PROJECT TITLE: GRADY RESIDENCE ZONE ATLAS/DRAINAGE FILE # C23/D7

It is proposed that the westernmost Drainage Easement line on Lot 133-A-1-B of Sandia Heights South Unit 2 subdivision be changed as described below. The reason for the change is to provide a suitable amount of usable land for a building site on the lot.

RE: DRAINAGE PLAN FOR RELOCATING DRAINAGE EASEMENT
LOT 133-A-1-B SANDIA HEIGHTS SOUTH, UNIT 2 (C-23/D7)

FIGURE 1
EASEMENT LINE CHANGE

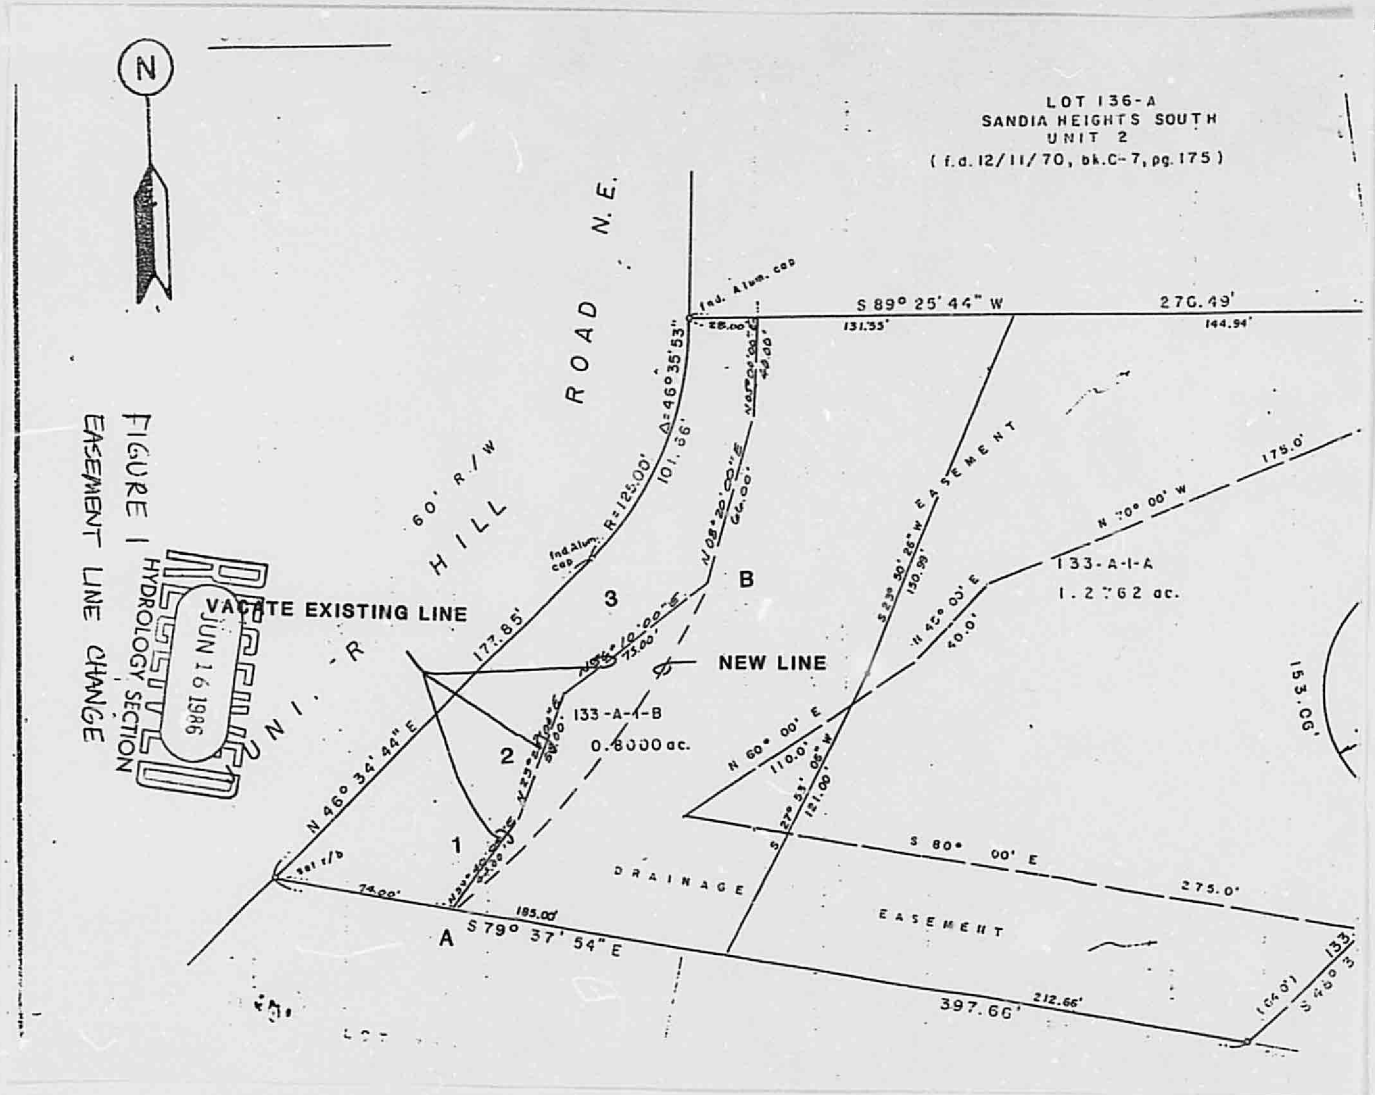
Extent of Change: sections 1, 2, and 3 of the existing west Drainage Easement line will be vacated between points A and B and will be replaced with an arc of a 400' radius circle as shown on Figure 1.

The south end of the proposed retaining wall (new easement line) is coincident with the existing easement line at the south property line (Figure 1, point A). The flow transition from Lot 133-A-1-B to the adjacent property to the south (Lot 303) will be smooth and identical to existing conditions. Thus, altering the west Drainage Easement line on Lot 133-A-1-B will have no impact on downstream properties.

FIGURE 3

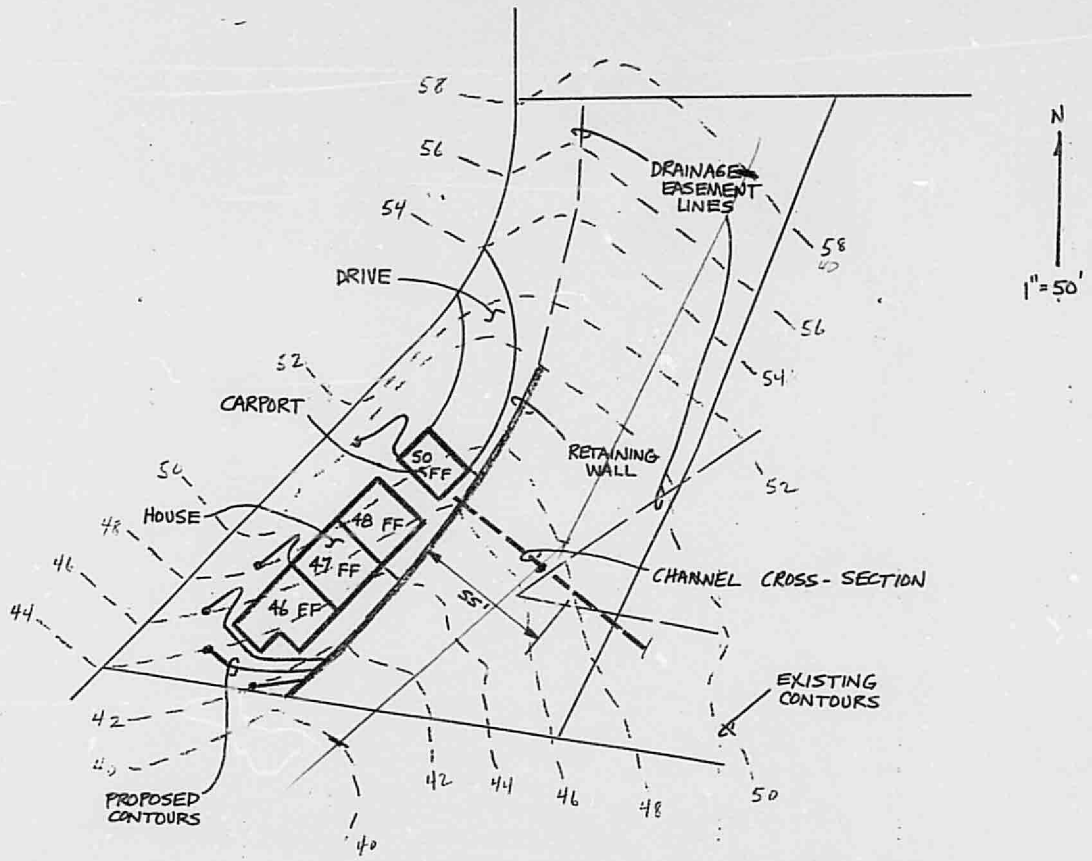
Method of Change: a concrete retaining wall will be designed and built on the proposed new Drainage Easement line. The wall will vary in height up to a maximum of approximately 4' above the arroyo bottom. The house site, west of the retaining wall, will have a finished floor elevation at least 3' above the projected 100-year storm high-water level. See Figure 3 for conceptual site grading.

TYPICAL SECTION - RETAINING WALL

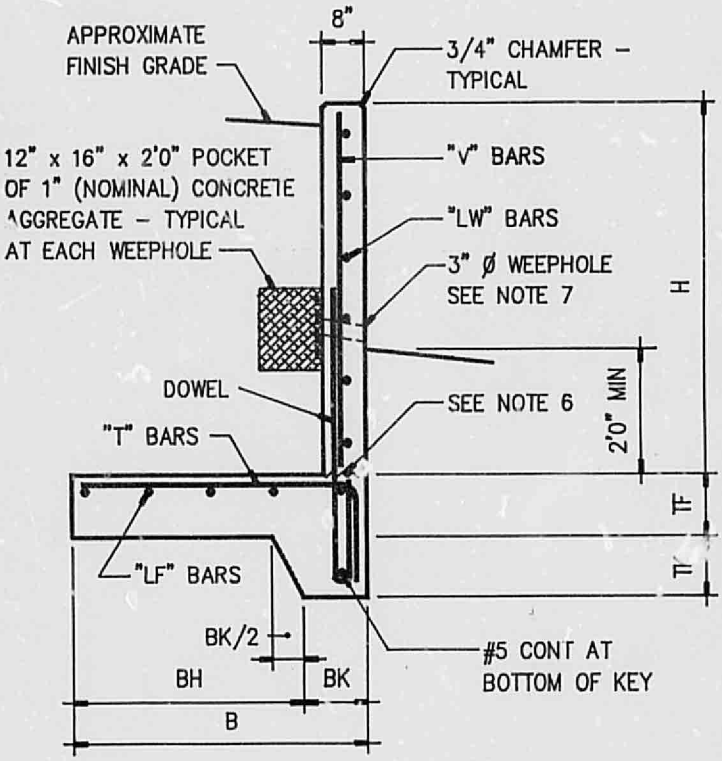
2. Please submit a cross section of the retaining wall indicating depth below ground level of the foundation. Erosion is our main concern in requesting this information.

2. Please submit a cross section of the retaining wall indicating depth below ground level of the foundation. Erosion is our main concern in requesting this information.

FIGURE 3

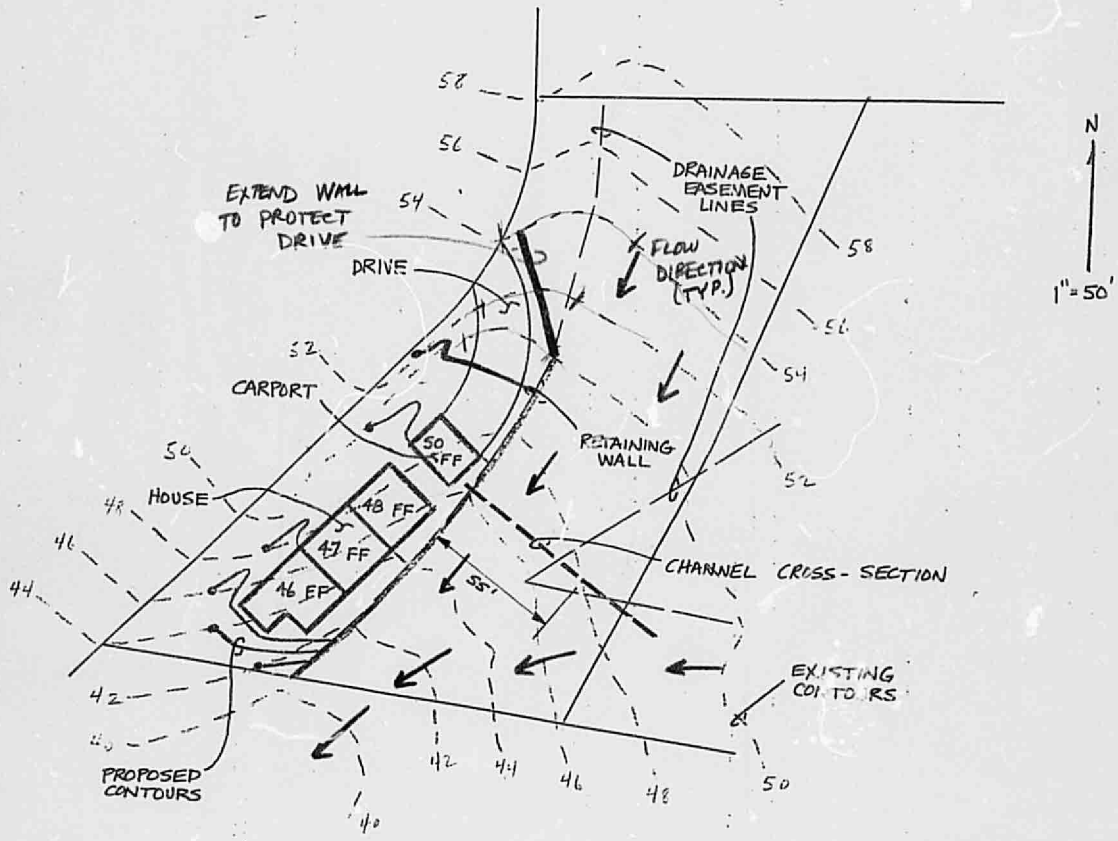
1 Please show top of wall and ground line elevations for the retaining wall. Depth of flow and the direction of flow toward the wall will determine the height of wall.

3 It appears that the retaining wall will need to wrap around the driveway at the north portion of the property. Please address this request.

✓ 3 It appears that the retaining wall will need to wrap around the driveway at the north portion of the property. Please address this request.

CLARIFIED 6/30/86

Revised 6/30/86

RETAINING WALL ELEVATION VIEW

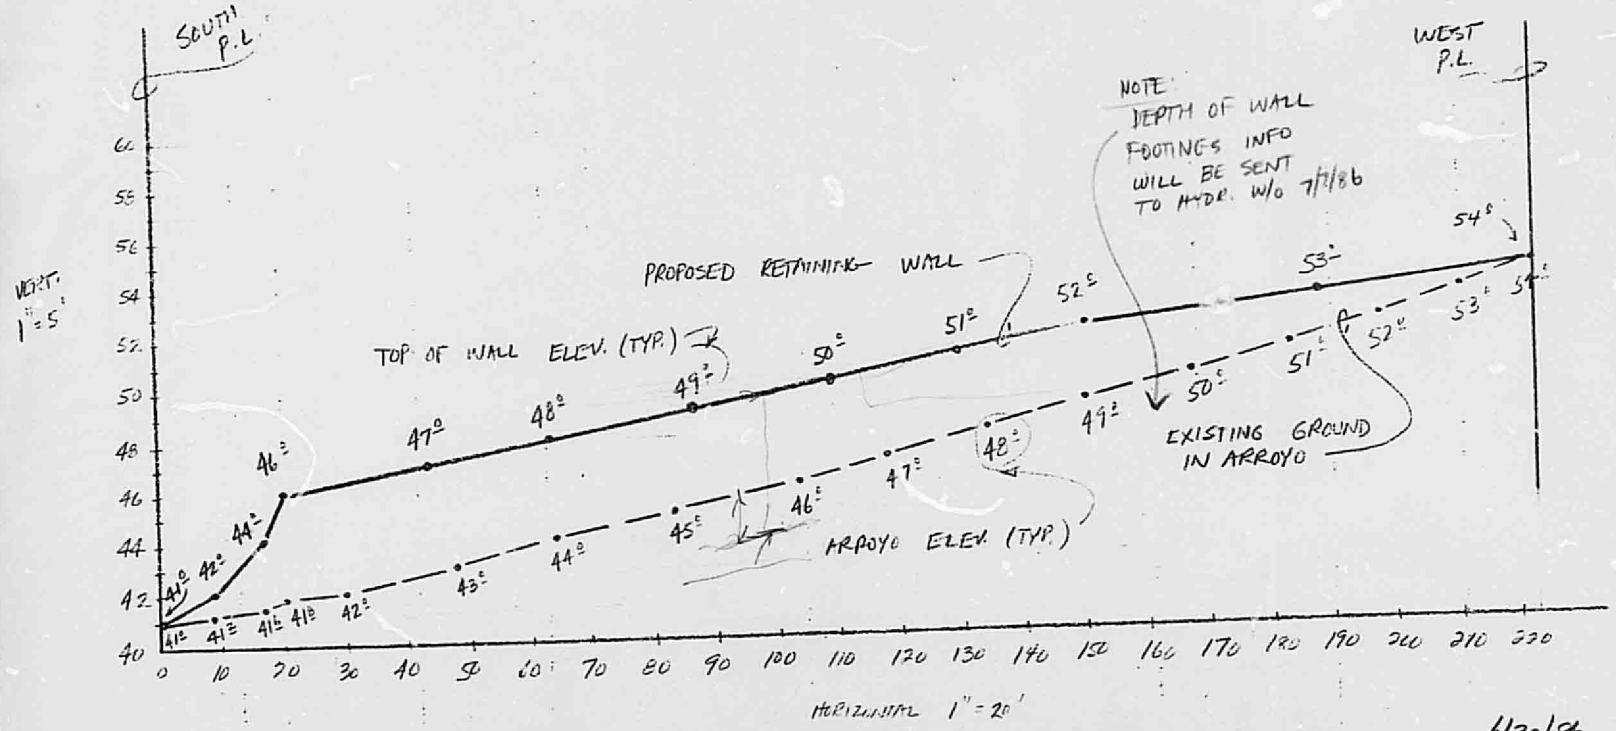
✓ 1 Please show top of wall and ground line elevations for the retaining wall. Depth of flo and the direction of flow toward the wall will determine the height of wall.

TO BE SUBMITTED WEEK OF 7/7/86
